CITY OF ALBUQUERQUE

**RE: Modwash - Eubank
Conceptual Grading & Drainage Plans
Engineer's Stamp Date: 03/24/23
Hydrology File: K20D060**

**RE: Modwash - Eubank
Grading & Drainage Plans
Engineer's Stamp Date: 02/07/23
Hydrology File: K20D060**

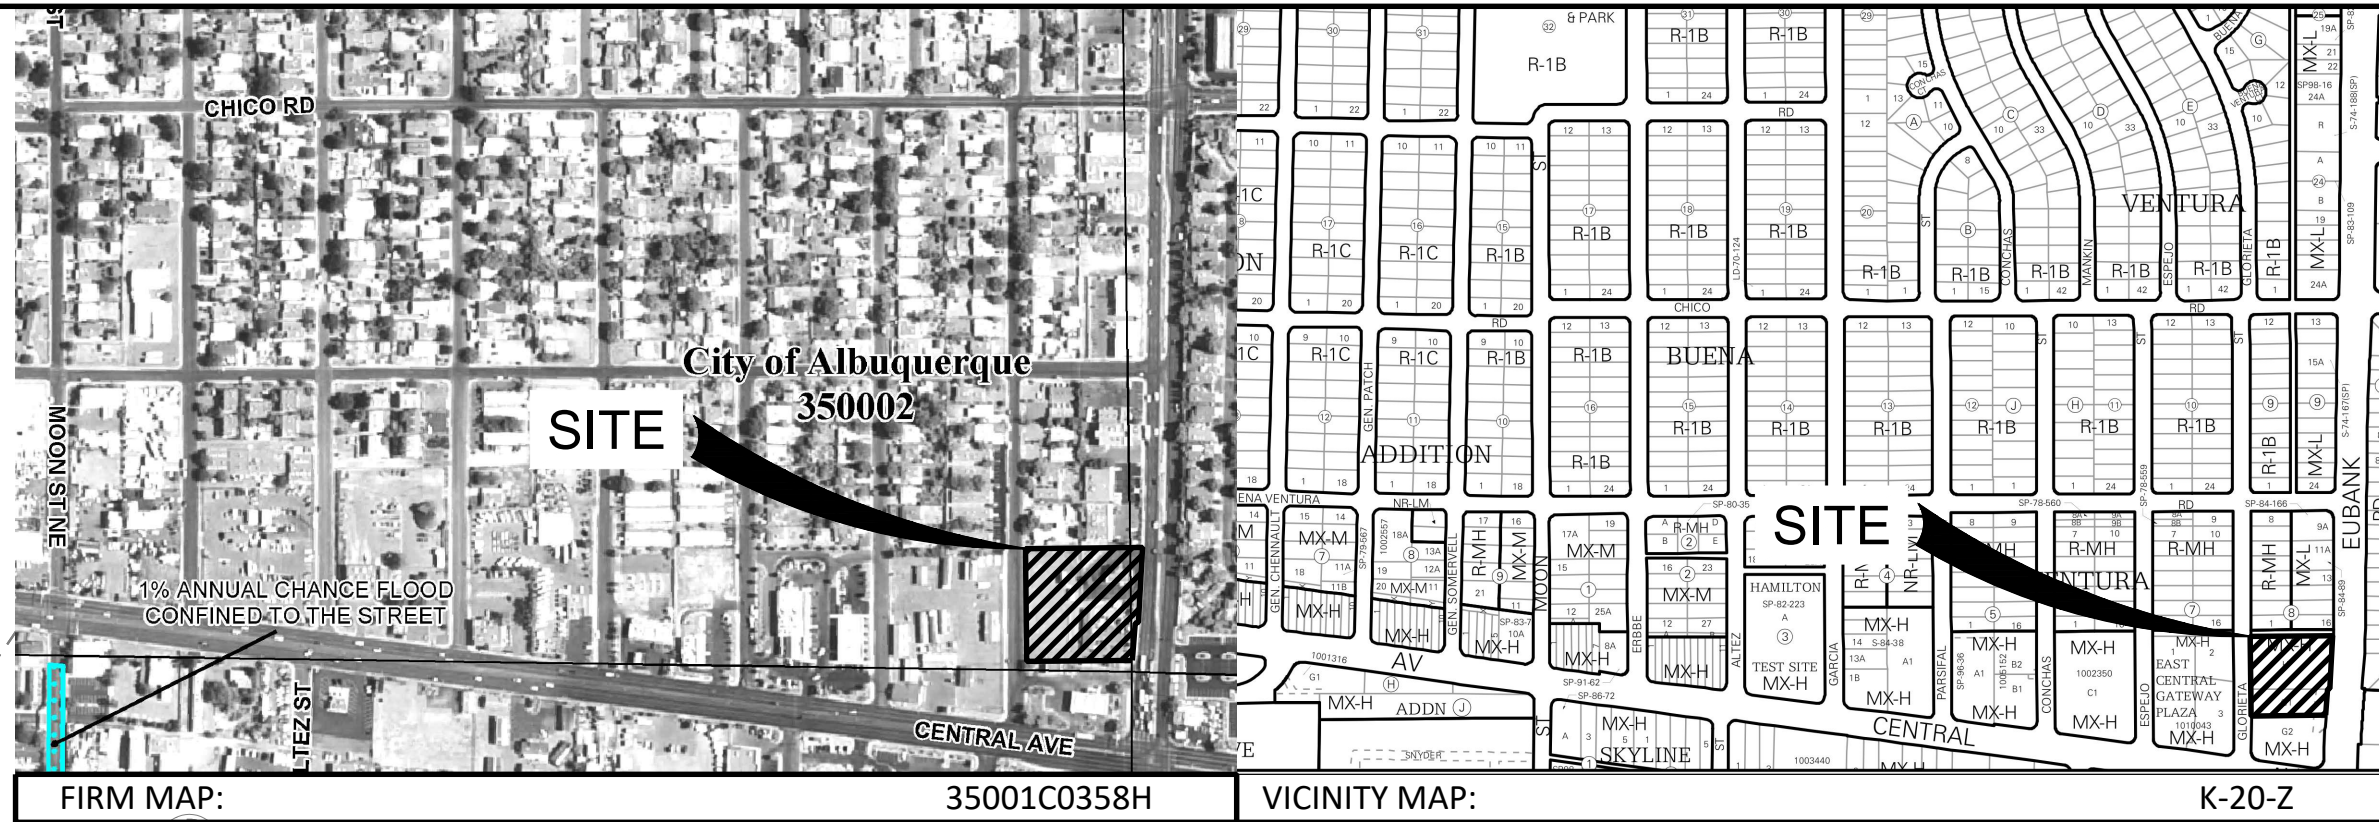
2. On Sheet C-103, Please ensure that the drainage flow arrows match the drainage flow arrows on Sheet C-104. There are a few that do not match. [I could not find any developed condition drainage flow arrows on sheet C-103 that conflicted with the slope labels on Sheet C-104. Please note that the slope arrows on sheet C-104 are provided to help the contractor visualize the longitudinal slope and cross slope of the drive aisles. These slope labels are not intended to be drainage flow arrows.](#)

5. On Sheet 103, please provide the weir calculations, per DPM Article 6-16(A), for the curb cuts and sidewalk culverts. A coefficient of 2.7 is typically used for the weir equation $Q = CLH^{2/3}$. [Revised.](#)

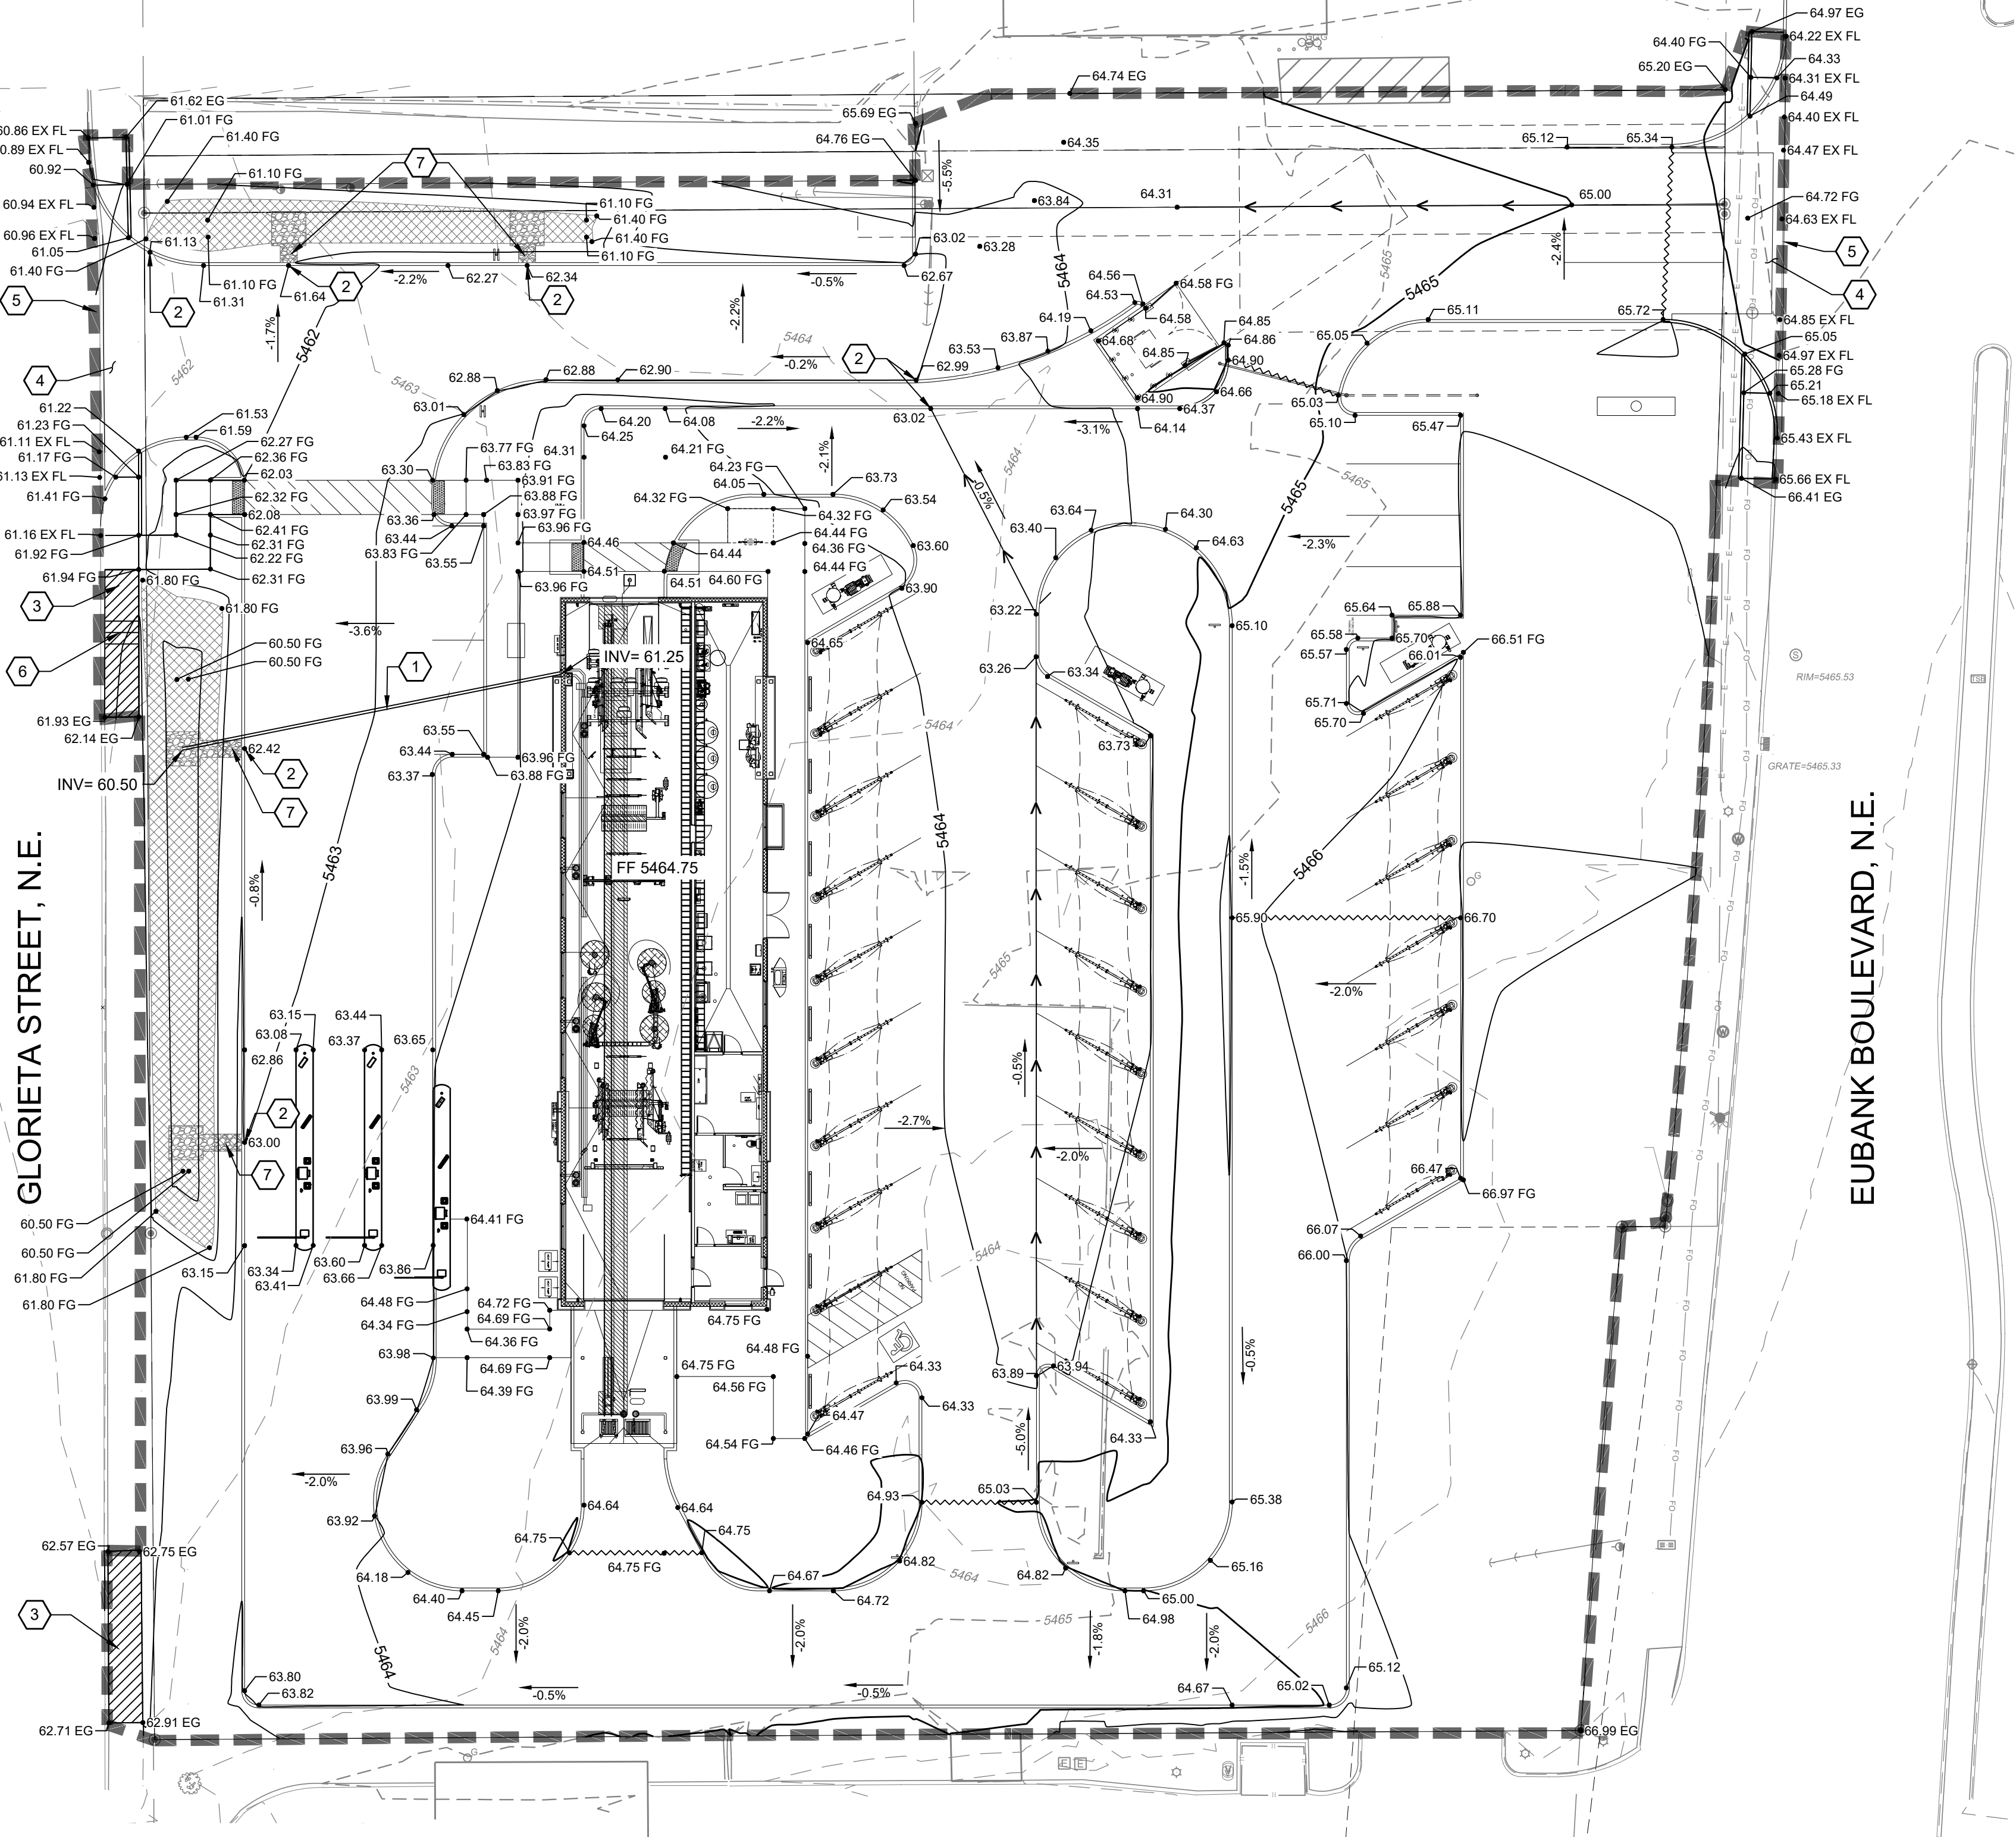
3. Since there is curb & gutter on the project, please remove the existing drive pad on Eubank and provide a private curb return per CoA Detail 2426. [Revised.](#)

4. Please provide a curb & gutter along the northern side of the proposed driveway on Eubank. This curb is needed to protect the existing metal electrical pole and existing billboard support beams. [Revised.](#)

6. On Sheet 104, please specify the curb cut width in Key Note #2. [Revised.](#)
7. On Sheet 104, please provide a sidewalk culvert for the spillway for the stormwater quality pond along Glorieta St. and label per CoA Detail 2236. [Revised.](#)

8. On Sheet 104, please provide the SO-19 Standard Notes, latest version. [Revised.](#)
